Access Compliance Report

Public Rights-of-Way

(Curb Ramps)

Intersection ID: N/A	Main Street: ORCHID_BRIDGE_RD	Cross Street: N/A	Location: N
ADA ID: 10B33FAA249B	Ramp Type: Perp	Initial Pass/Fail: Fail	Overall Compliance: No
		Severity Score: 12.5

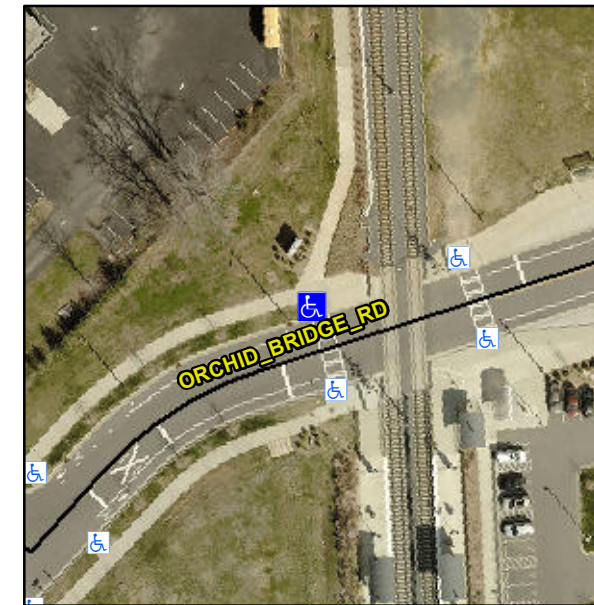
R304.2.2

Compliance	Description	Data	Compliance	Description	Data
N/A	Ramp Length (in)	97.0	No	Ramp Slope (%)	9.5
Yes	Ramp Width (in)	48.0	Yes	Ramp XSlope (%)	1.7
N/A	Flare Type LT	N/A	N/A	Flare Type RT	N/A
N/A	Flare Slope LT (%)	N/A	N/A	Flare Slope RT (%)	N/A
N/A	Flare Traversable LT?	N/A	N/A	Flare Traversable RT?	N/A
N/A	Landing Length (in)	N/A	N/A	DWS Provided?	N/A
N/A	Landing Width (in)	N/A	N/A	DWS Contrast?	N/A
N/A	Landing Slope (%)	N/A	N/A	DWS Length (in)	N/A
N/A	Landing X Slope (%)	N/A	N/A	DWS Full Width?	N/A
N/A	Landing Curb? (Y/N)	N/A	N/A	DWS Offset (in)	N/A
N/A	Shared Landing?	N/A			
N/A	Gutter Ponding?	N/A	N/A	Gutter Slope (%)	N/A
N/A	Gutter Lip Ht (in)	N/A	N/A	Gutter X Slope (%)	N/A
N/A	Painted X Walk1?	Yes	N/A	Painted X Walk2?	N/A
	X Walk 1 Direction	To S		X Walk 2 Direction	N/A
N/A	X Walk 1 Width (in)	104.0	N/A	X Walk 2 Width (in)	N/A
	X Walk 1 Slope (%)	1.5		X Walk 2 Slope (%)	N/A
	X Walk 1 X Slope (%)	1.1		X Walk 2 X Slope (%)	N/A

Remove & Replace Entire Ramp.
